**EP Interrogatory #14**

**Issue:** Are the proposed nuclear capital expenditures and/or financial commitments for the Darlington Refurbishment Program reasonable?

**Board Staff Interrogatory #64**

**Figure C2: Darlington Refurbishment LUEC Components**

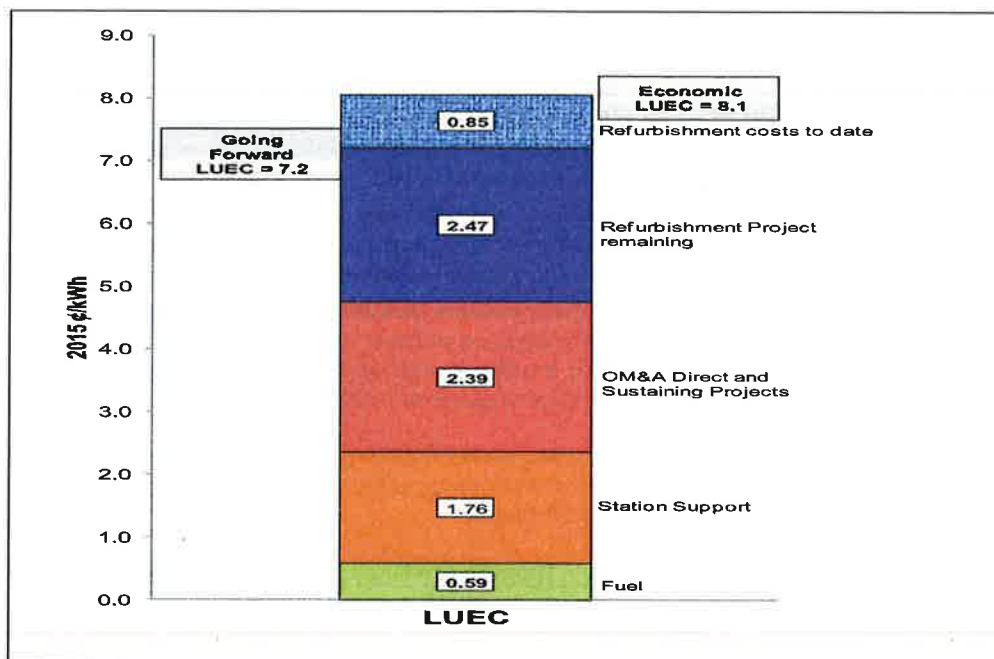
The above reference states that OPG's current Levelized Unit Energy Cost (LUEC) estimate of 8.1 ¢/kWh (2015\$) for the DRP is within the previously communicated estimate of 8 ¢/kWh in 2009\$.

- a) What total cost can the DRP rise to in 2026\$ that would still be equivalent to the LUEC 2009 at less than 8 ¢/kWh?
- b) Please calculate the LUEC when the full \$12.8B is used.
- c) Please calculate the LUEC when the costs related to previous DRP projects that have been moved to Nuclear Operations is added back.

- b) The LUEC of 8.1¢/kWh (2015\$) provided in Ex. D2-2-8 Attachment 1 is calculated using the full \$12.8B.
- c) If the costs for the projects reclassified to Nuclear Operations (see Ex. D2-2-10 p. 10-11) were to be added to the DRP costs, the LUEC would increase to approximately 8.25¢/kWh (2015\$).
